NORTHRIDGE ESTATES

RE: S/D 96-60, Final Plat of the NORTHRIDGE ESTATES ADDITION

STAFF REPORT

CASE NUMBER: S/D 96-60 - NORTHRIDGE ESTATES ADDITION

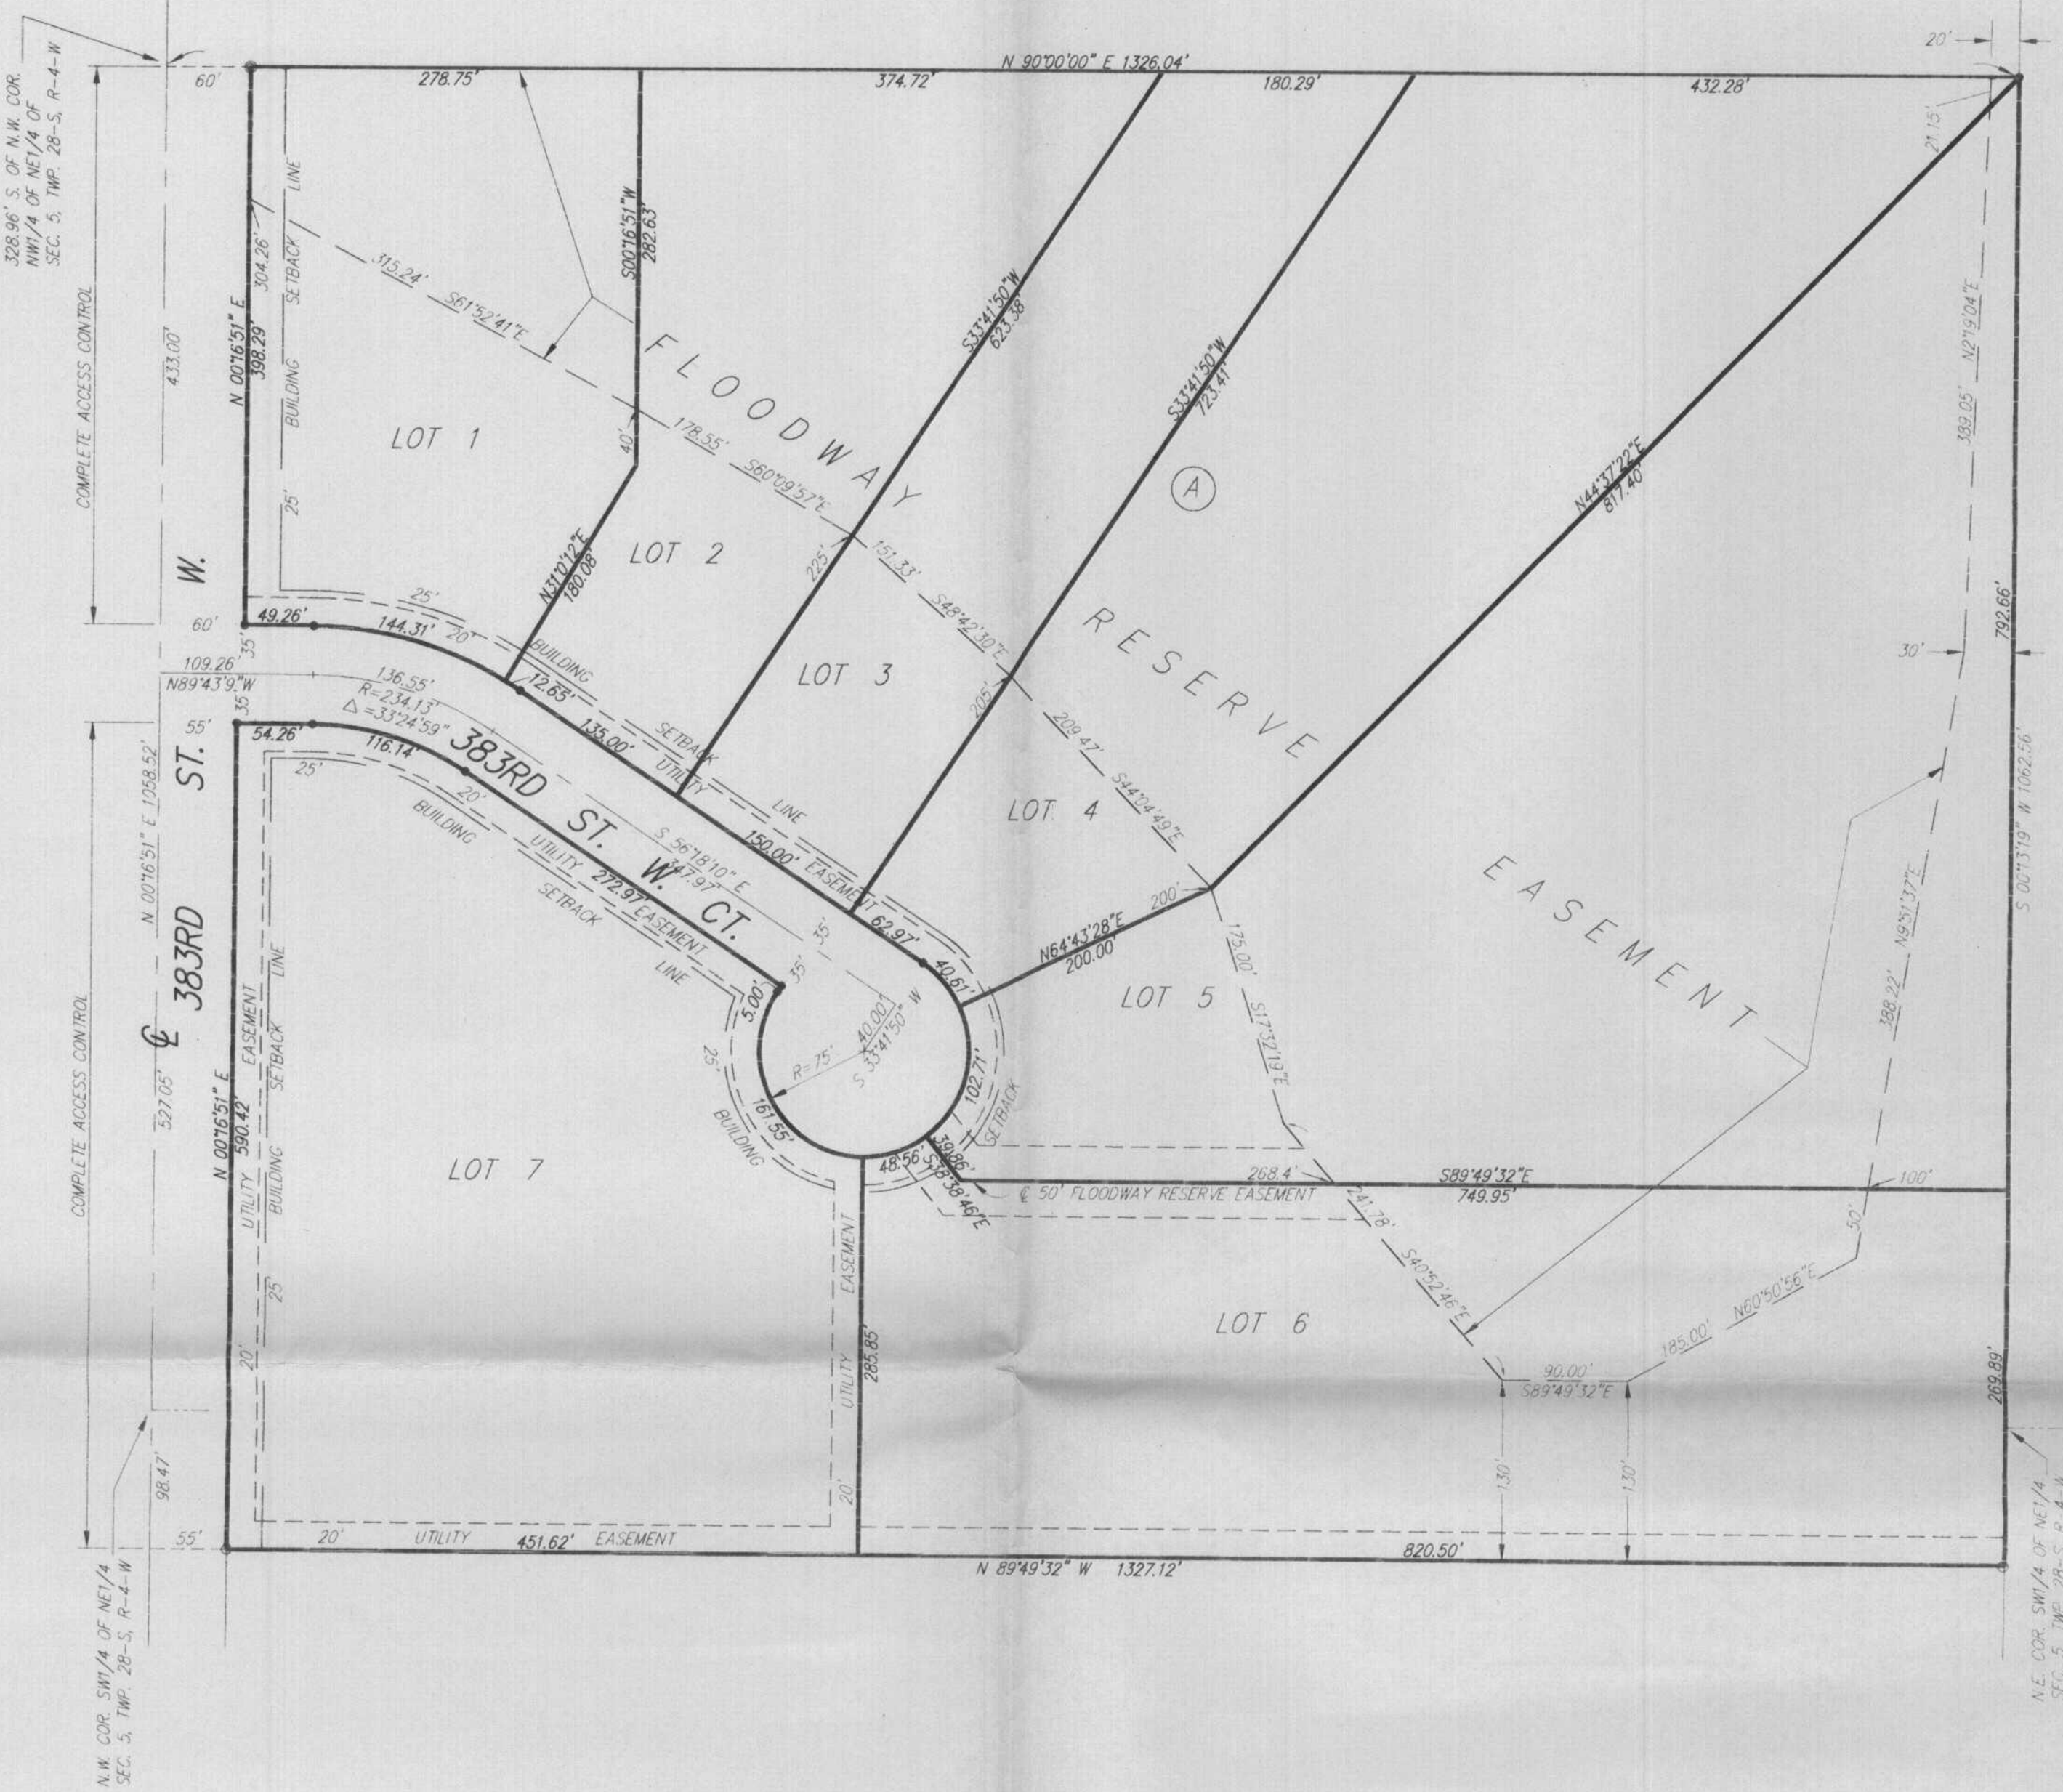
A. The applicant shall submit a letter from the City of Cheney indicating whether this site needs to participate in the extensions of facilities from that City. If facilities (water, sanitary sewer, natural gas) can be made available from Cheney, this letter shall also note that the applicant has made satisfactory arrangements for such improvements. Note, the final plat will not be scheduled for Subdivision Committee review until such time as the City of Cheney has had an opportunity to comment on this plat. Prior to submitting the final plat, the applicant is encouraged to meet with Cheney officials to discuss and resolve any possible concerns.

B. Since neither municipal water nor sanitary sewer is available to serve this property, the applicant shall contact the Environmental Health Division of the Health Department to find out what tests may be necessary and what standards are to be met for approval of on-site sewerage facilities and water wells. A memorandum shall be obtained specifying approval. Based on the lot sizes being platted, this approval must be for the use of septic sanitary sewer systems.

However, Lots 7 and 8 shall be combined into one lot with either septic or lagoon sanitary sewer used if allowed by the Health Department. For the other lots of this plat, because of limited usable area, a covenant as required by the Health Department shall be provided for recording which clearly specifies that restrictions are involved for the location of homes, related uses and on-site sanitary sewer for these lots. This covenant shall also

note that a site development plan shall be submitted to Health as part of the on-site sanitary sewer application and will be subject to Health Department approval. Also, a note shall be placed on the face of the plat noting the filing of such a covenant. This covenant needs to be reviewed and approved by the Health Department then submitted to Planning for recording with the plat.

C. LCC to County
The applicant shall guarantee with the County, the installation of the interior street to the suburban, gravel standard.

D. During review of the preliminary plat, it was stated and approved that since Cheney Spur is a major north-south street connecting U.S. 54 and Cheney, all lots adjacent to that street shall be platted with complete access control. Also that a guarantee shall, therefore, be provided to close the opening shown at the southwest corner of Lot 7.

However, this final plat is continuing to show an access opening to 383rd Street West from Lot 7. At this time, apparently, an existing use on what is being platted as Lot 6, has driveway access out to 383rd Street West. Also, a use to the south appears to be using this opening for access. The plat is indicating a 40-foot easement to the interior cul-de-sac, which would apparently be to the benefit of the use south of the site. Also, the uses on Lot 6 would be expected to use the interior street when it is constructed. Consequently, the opening to 383rd Street West, appears to be a temporary need until such time as the interior street is constructed.

Therefore, the opening from Lot 7 only be allowed as temporary access. A contingent dedication of complete access control by separate instrument shall be provided and words to that effect shall be placed in the plat's text. The contingency itself stating that complete access control to 383rd Street West from Lot 7 will occur when 383rd Street West Ct. is constructed.

E. The applicant shall guarantee any drainage improvements required by the platting of this property.

(F) not shown
The 40-foot ingress and egress easement along the west line of Lot 6, if created by separate instrument, needs to have indicated the recording information for the easement on the plat. Unless this easement is for a public purpose, its creation (as a private type easement) through platting is not appropriate.

G. Approval of this plat by the MAPC will indicate waiver of the lot depth to width standard (not more than 2½ times width).

- L. The applicant's agent shall submit a properly prepared plat binder/title report. The copy provided with the final plat for example does not even indicate who prepared the policy and is unsigned or not documented.

- M. Perimeter closure computations shall be submitted with the final plat tracing. Section 5-101(c).
- N. Recording of the plat within 30 days after approval by the City Council and/or County Commission.

- O. As noted by County Engineering during the Subdivision Meeting of November 7, 1996, the term "Easement" needs to be deleted from the area shown as a "Floodway Reserve" on the face of the plat. Also, the plattor's text shall be amended to delete reference to an easement when associated with the Floodway Reserve. Further, Lots 3, 4, 5 and 6 shall indicate a minimum building pad elevation of 1364'.
